Model: Stinger-C1 Paper Tray Unit / 2 Trays (PS410) Date				e: 15-Dec-9	9	No.: MA860001		
Modified Article: Part number change					Prepared by: K. Miura			
From: Technical Services Dept., GTS Division								
Reason for	☐ Parts catalog correction	⊠ Vend	lor ch	ange	☐ To n	neet standards		
Modification:	☐ To facilitate assembly	☐ To improve reliability		e reliability	()		
	☐ Part standardization	Othe	r

Model: Stinger-C1 Paper Tray Unit/1Tray (PS410)			Date	e: 15-Dec-9	9	No.: MA860002
Modified Article: Spring Guard					by: K. I	Miura
From: Technical Services Dept., GTS Division						
Reason for	Parts catalog correction	☐ Vend		ū	☐ To m	neet standards
Modification:	☑ To facilitate assembly	☐ To in	☐ To improve reliabil		()
	☐ Part standardization	Other

Modification Bulletin

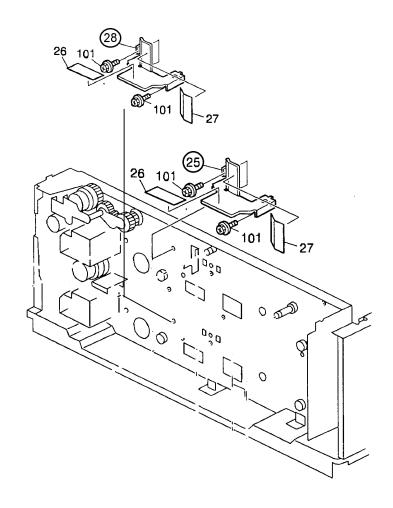
The shape of the spring guard has been modified to facilitate removal.

Old part	New part	Description	Q'ty	Int	Page	Index	Note
number	number						
A8601190	—A8601190	Guard: Spring: Paper Bank	2-1		11	25	
	—A8601191	Spring Guard – Lower	1	O/O	11	28

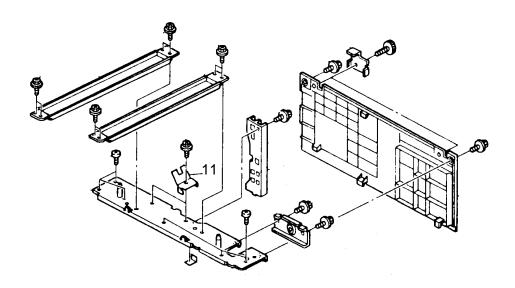
For increased safety, a mylar strip has been added to both plate springs located in between the paper feed unit and mainframe.

Old part number	New part number	Description	Q'ty	Int	Page	Index	Note
H5194547	A8601140	Spring Plate	2	X/O	3	11

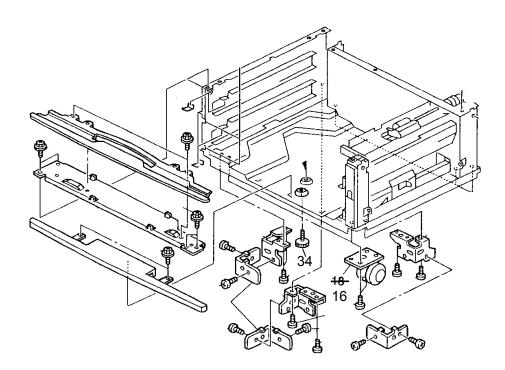
An adjusting pin has been added to the Paper Tray Unit to make it easier to secure the unit in place. This will function in place of the Paper Tray Unit caster locks.

Old part	New part	Description	Q'ty	Int	Page	Index	Note
number	number						
AH012025	AH012026	Caster	2-4	X/O	3	18-16	
	A8601125	Adjusting Pin	1		3	34

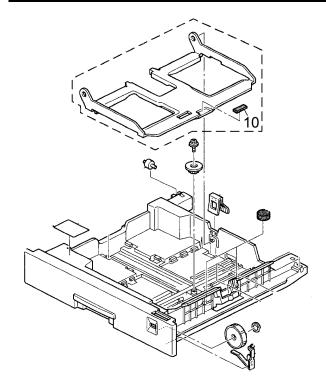
In order to ensure proper feed of OHP transparencies, a material with a lower rubber content is now used for the bottom plate pad. This material has a lower coefficient of friction and is effective against the following OHP feed symptoms.

- Last sheet non-feed (jam display)
- Skewing
- Noise

Old part	New part	Description	Q'ty	Int	Page	Index	Note
number	number						
G0292608	52152713	Bottom Plate Pad	1	X/O	5	10

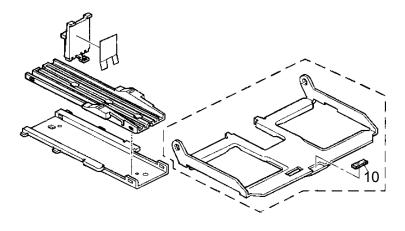
Due to the measurement specifications of the bottom plate pad, it is possible for the pad to be wider than the opening in the bottom plate. To ensure that the pad will fit in the opening, the base pad for the Russian will be used.

Old part	New part	Description	Q'ty	Int	Page	Index	Note
number	number						
52152713 —	7	Bottom Plate Pad	1	0/0	5	10	
	^L A2672917	Base Pad	1	0/0	5	10

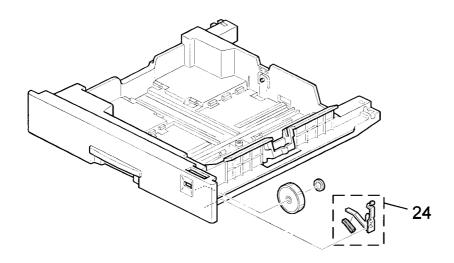
The edge of the spring pate for the paper size dial is relatively sharp. To ensure proper safety, a sponge has been added to the plate.

Old part	New part	Description	Q'ty	Int	Page	Index	Note
number	number						
A2672868	A2672870	Sponge – Spring Plate	1	X/O	5	24

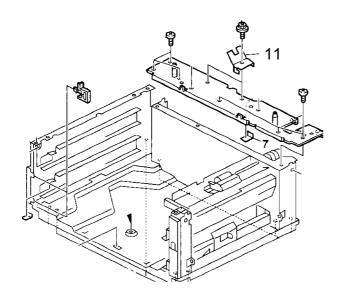
Although previously, a mylar was added to the spring plate to protect it from damage (MB #MA861003), the shape of the spring plate itself has now been modified to perform the same function.

Old part number	New part number	Description	Q'ty	Int	Page	Index	Note
I	A8601140	B3841146	Spring Plate	2	X/O	3	11

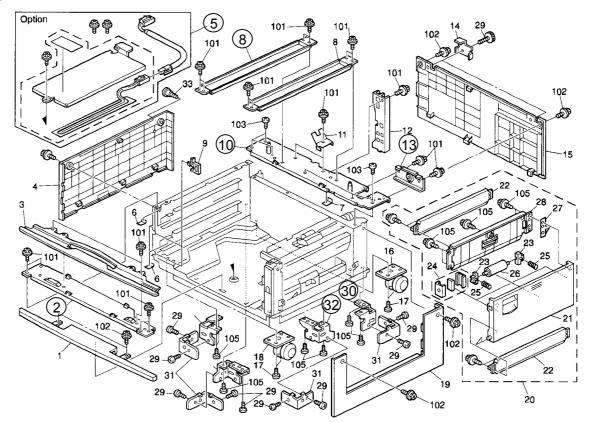
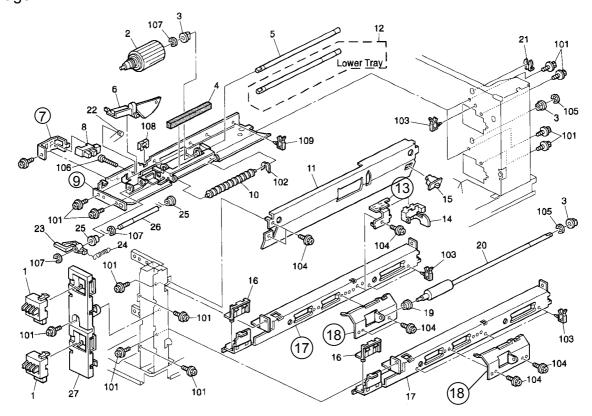
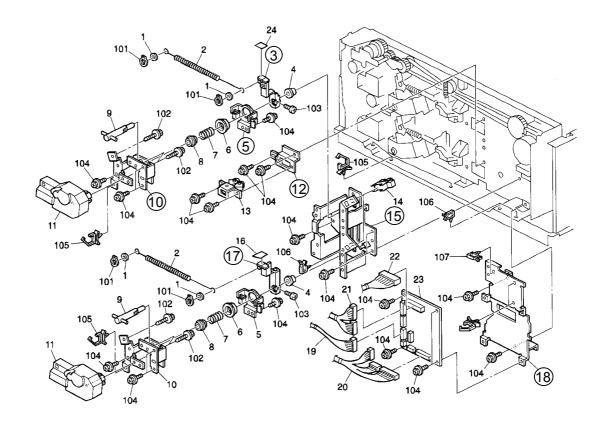
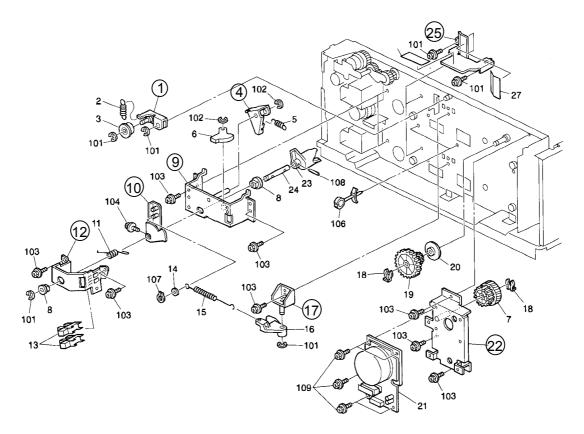
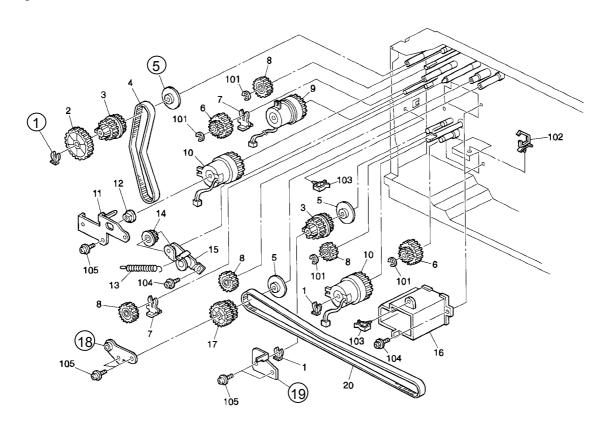
A material change has been applied to the following brackets and bracket portions of the following components.

Old part	New part	Description	Q'ty	Int	Page	Index	Note
number	number						
A8601110	B3841110	Upper Front Stay	1	O/O	3	2	
A8601114	B3841114	Upper Rear Stay	1	O/O	3	10	
A8601117	B3841117	Bracket - Upper Rear Stay	1	O/O	3	13	
A8601120	B3841120	Upper Left Stay	2	O/O	3	8	
A8606260	B3846260	Unit Holder Bracket - LF/RR	2	O/O	3	30	
A8606270	B3846270	Unit Holder Bracket - RF/LR	2	O/O	3	32	
A8606300	B3846300	Tray Heater	1	O/O	3	5	
A2672660	B0242660	Vertical Sensor Bracket	1	O/O	7	13	
A2672805	B0242805	Bracket - Paper End Sensor	2	O/O	7	7	
A2672842	B0242842	Bracket - Friction Pad Guide	2	O/O	7	18	
A8601090	B3841090	Right Guide Rail	2	O/O	7	17	
A8602555	B3842555	Feed Roller Bracket	2	0/0	7	9	
A2672908	B0242908	Tray Holder Bracket	2	0/0	9	12	
A8601161	B3841161	Interface Board Bracket	1	0/0	9	18	
A8602709	B3842709	Upper Lever - Lift Motor	1	O/O	9	3	
A8602720	B3842720	Main Bracket - Lift Motor	1	O/O	9	15	
A8602726	B3842726	Lift Motor Bracket	2	O/O	9	10

A8602728	B3842728	Spring Holder Bracket	2	0/0	9	5	
A8602895	B3842895	Lower Lever - Lift Motor	1	0/0	9	17	
A2672765	B0242765	Pressure Lever Stopper	1	0/0	11	4	
A2672773	B0242773	Lift Sensor Bracket	1	0/0	11	12	
A2672781	B0242781	Pressure Lever Bracket	2	0/0	11	17	
A2672815	B0242815	Main Bracket - Pressure Lever	1	0/0	11	9	
A8601190	B3841190	Upper Spring Guard	1	0/0	11	25	
A8601191	B3841191	Lower Spring Guard	1	0/0	11	28	
A8602810	B3842810	Main Motor Bracket	1	0/0	11	22	
A8602821	B3842821	Timing Belt Tensioner	1	0/0	11	1	
A8602893	B3842893	Actuator - Paper Height Sensor	2	O/O	11	10	
A2672602	B0242602	Timing Belt Tensioner	1	O/O	13	5	
A8602840	B3842840	Bracket - Paper Feed Clutch	1	O/O	13	1	
A8602850	B3842850	Lower Bracket - Paper Feed	1	O/O	13	19	
A8602860	B3842860	Upper Bracket - Paper Feed	1	0/0	13	18

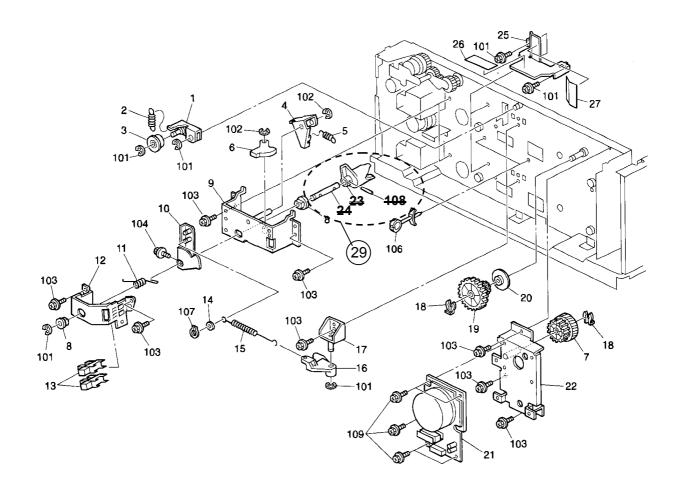
Please correct your Part Catalog as follows:

Old part	New part	Description	Q'ty	Page	Index	Note
number	number					
A2672761 -		Joint – Shaft	1	11	23	
A2672762 -	†	Shaft	1	11	24	
06230140E -		Spring Pin – 3x14mm	1	11	108	
	L A2672756	Joint - Shaft	1	11	29

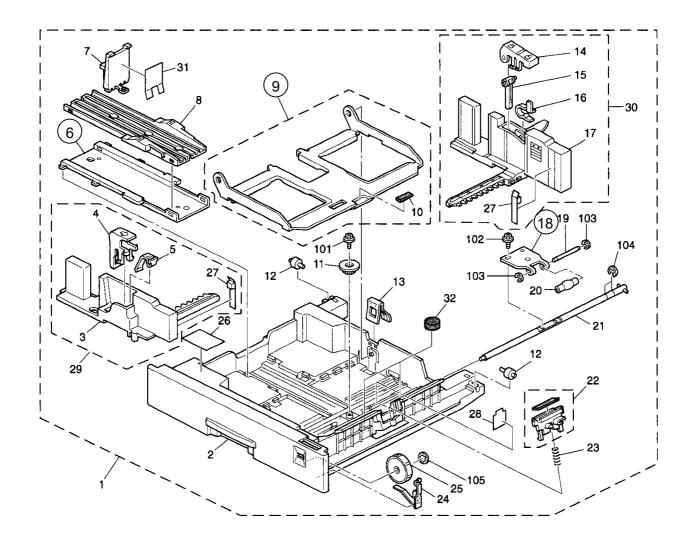
A material change has been applied to the following brackets and bracket portions of the following components.

Old part	New part	Description	Q'ty	Int	Page	Index	Note
number	number						
A2672874	B0242874	Base Slider	1	O/O	5	6	
A2672861	B0242861	Bottom Plate	1	O/O	5	9	
A2672856	B0242856	Bracket - Rising	1	0/0	5	18

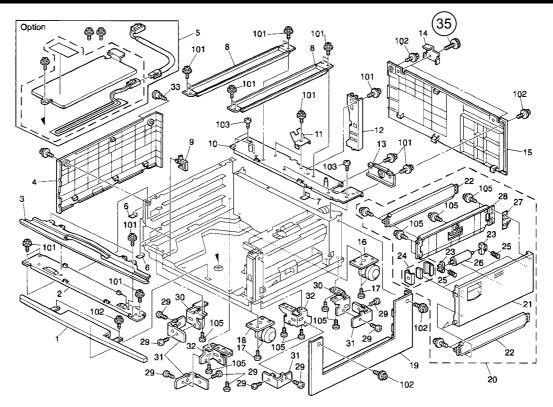
To maximize the Rear Cover's resistance to warping under high temperatures (over 60°C), the M4x10 Flat Knob Screw for the cover has been changed to an M4x11 screw in the **two areas** shown below (index 35).

Note: Since the M4x10 screw (index 29) is still being used in the remaining areas, its service parts quantity has been changed from 10 to 8 with no P/N change.

1	Old part	New part	Description	Q'ty	Int	Page	Index	Note
	number	number						
I	AA143508	- AA143508	Flat Knob Screw – M4x10	10-8		3	29	
1		AA143775	Screw: M4x11	2	X/O	3	35

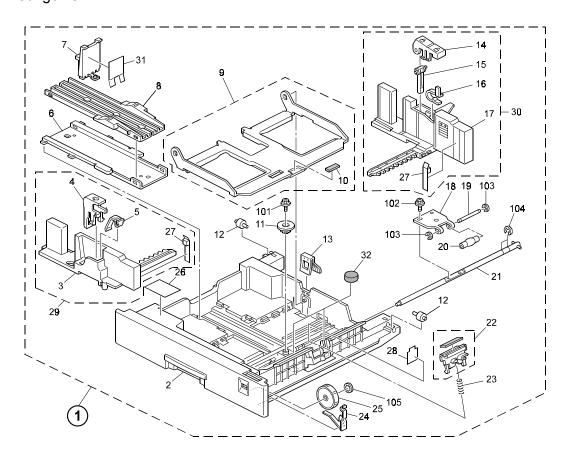
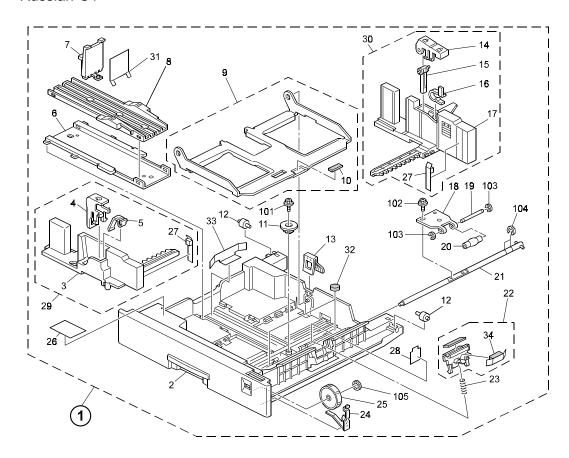
The following has been changed to ensure that the Paper Tray can be inserted and pulled out more smoothly.

Old part number	New part number	Description	Q'ty	Int	Page	Index	Note
A8607341	A8607342	Paper Tray Assembly	1	0/0	5	1
